TECHNICAL EVALUATION REPORT  
INDIAN POINT UNIT 2  
STATION BLACKOUT EVALUATION

TAC No. 68556

Final  
November 21, 1990

U.S. Nuclear Regulatory Commission  
Washington, D.C. 20555

FIGURE 1. INDIAN POINT 2 ALTERNATE AC POWER SYSTEM

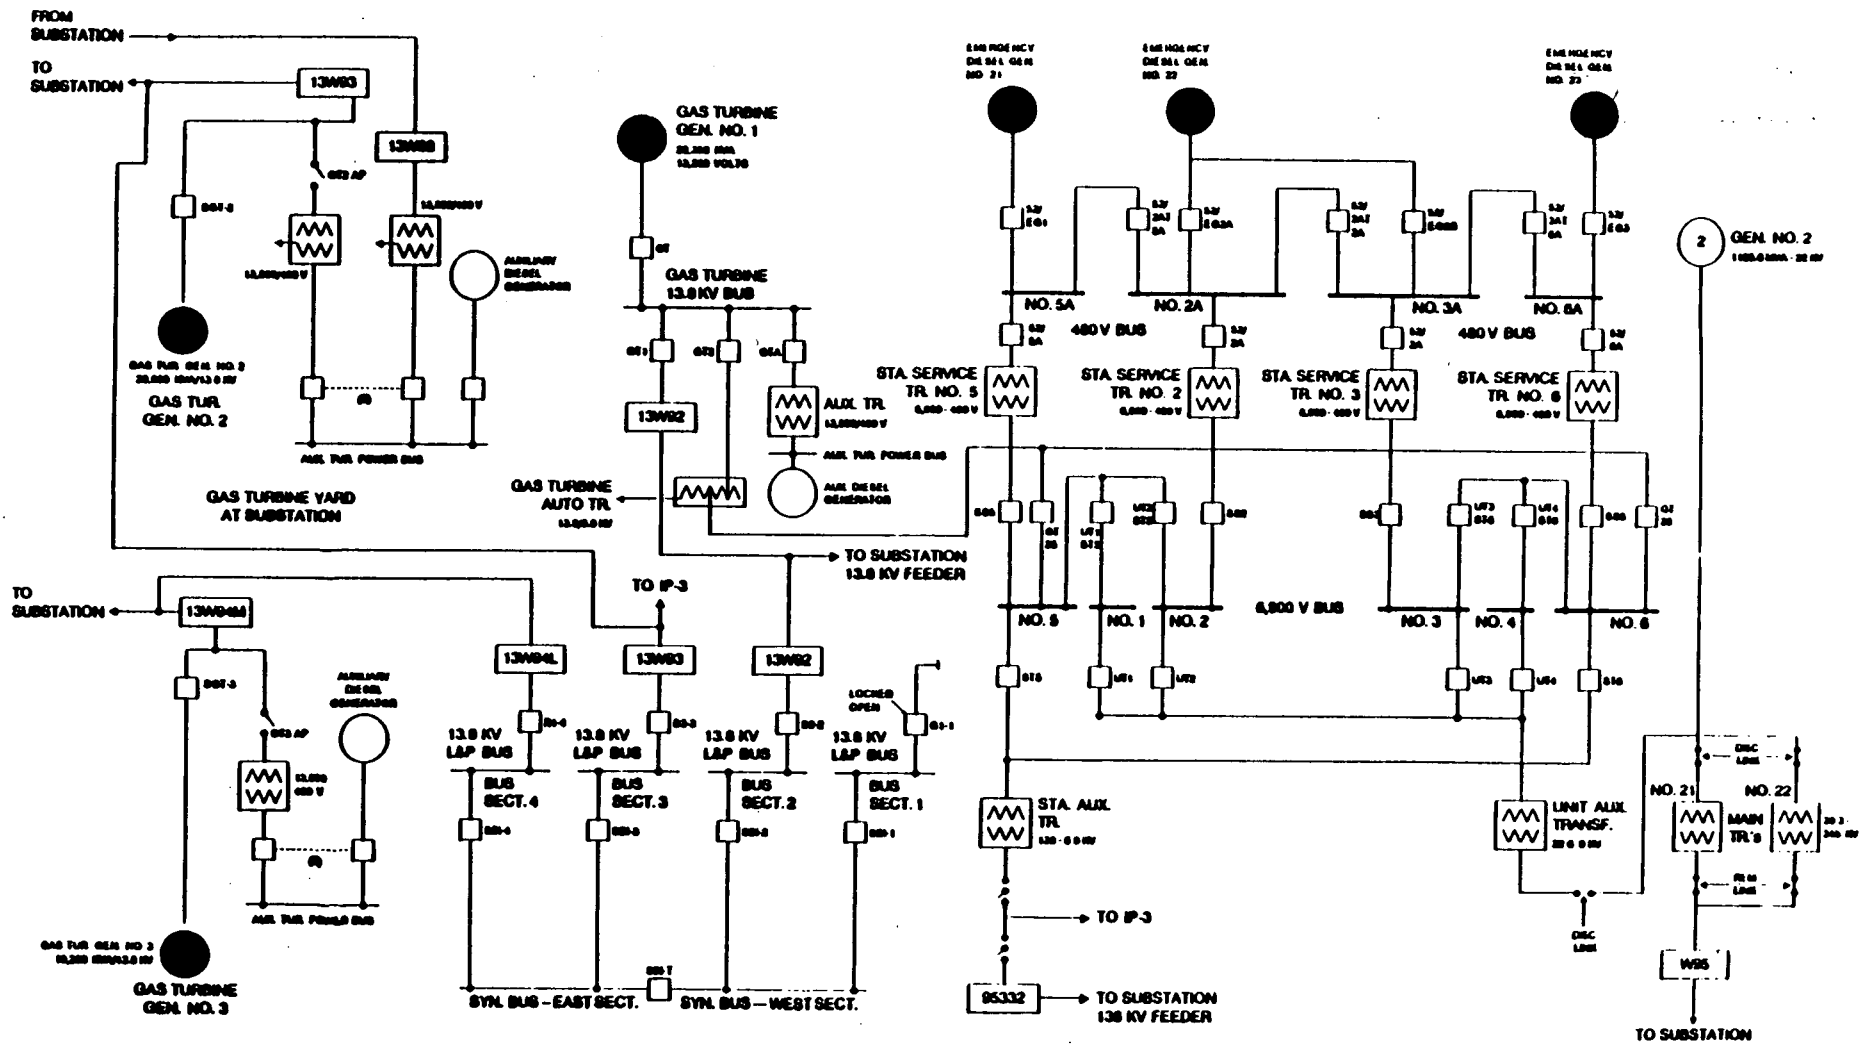
One of the AAC power sources (GT-1) is located on the Indian Point Unit 1 (IP-1) property, which is directly adjacent to the IP-2, the other two sources (GT-2 and GT-3) are located at the Buchanan substation, which is located about half a mile from IP-2. GT-2 and GT-3 feed power through three underground (13.8 kV) feeders to IP-1 switchgear. IP-2 can receive power from IP-1 switchgear, and any of the three gas turbines via an underground 13.8 kV feeder line.

The licensee stated that GT-1 and GT-3 have blackstart capabilities and that GT-2 currently has limited blackstart capability. A blackstart diesel generator will be installed to give GT-2 a complete remote blackstart capability from the IP-2 control room.

The licensee stated the plant Technical Specifications requires that at least one gas turbine to be available during reactor operation (with a seven day LCO), and that monthly surveillance testing be performed on all gas turbines. The licensee stated that the existing maintenance and surveillance procedures for the gas turbines meet the guidance provided in NUMARC 87-00, Appendix B.

The licensee committed to demonstrate that each of the AAC power sources can power the shutdown busses within one hour of the onset of an SBO, in accordance with NUMARC 87-00 Sections 7.1.2 and Appendix B, Paragraph B.12, and RG 1.155, Section 3.3.5.3.

Based on the telephone conversation on June 4, 1990, and the information available in the plant's UFSAR, we conclude that following the completion of the above modification and tests, the licensee's AAC system will meet the criteria given in the guidance of NUMARC 87-00, Appendix B.
